United States Patent and Trademark Office

APPLICATION NO. FILING DATE		NG DATE	FIRST NAMED INVENTOR	ATTORNEY DOCKET NO.	CONFIRMATION NO.
10/692,141 10/23/2003		23/2003	Jin Shenghao	15865.8a.1	9173
22913	7590	07/06/2006	EXAMINER		
WORKMA	N NYDEG	GER	HAWK, NOAH CHANDLER		
(F/K/A WOI 60 EAST SO		DEGGER & SEE LE	ART UNIT	PAPER NUMBER	
1000 EAGL	E GATE TO	WER	3636		
SALT LAKI	ECITY, UT	84111	DATE MAILED: 07/06/2006

DETAILED ACTION

Lin, Figure 1 (detail)

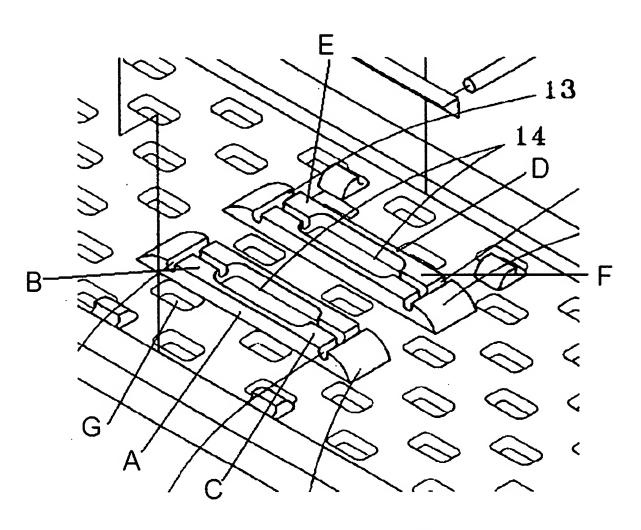
- 6. Claims 27-31 are rejected under 35 U.S.C. 102(e) as being anticipated by Lin in US Publication 2003/0233967.
 - a. Regarding Claims 27 and 28, Lin teaches a table with a blow molded tabletop (see Lin, paragraph 0017 "table plate 1 is made by a blow molding method") with first and second leg assemblies (23) movable between extended and collapsed positions, a support assembly having a first (A) and second (D) mounting structures integrally formed in the table top, first and second support

members (27), first and second crossbars (26), and a recessed portion (G) formed in the outer surface of the mounting structure to form at least part of a handle.

b. Regarding Claim 29, Lin further teaches that the mounting structures have a generally C-shaped configuration and first (B and E respectively) and second

(C and F respectively) ends and that the mounting structures are spaced apart from and facing each other.

- c. Regarding Claim 30, Lin further teaches that the first and second ends of the first and second mounting structures are aligned and spaced apart from each other.

- d. Regarding Claim 31, Lin further teaches a recessed portion (G) integrally formed in the lower portion of the tabletop to form at least part of the handle.
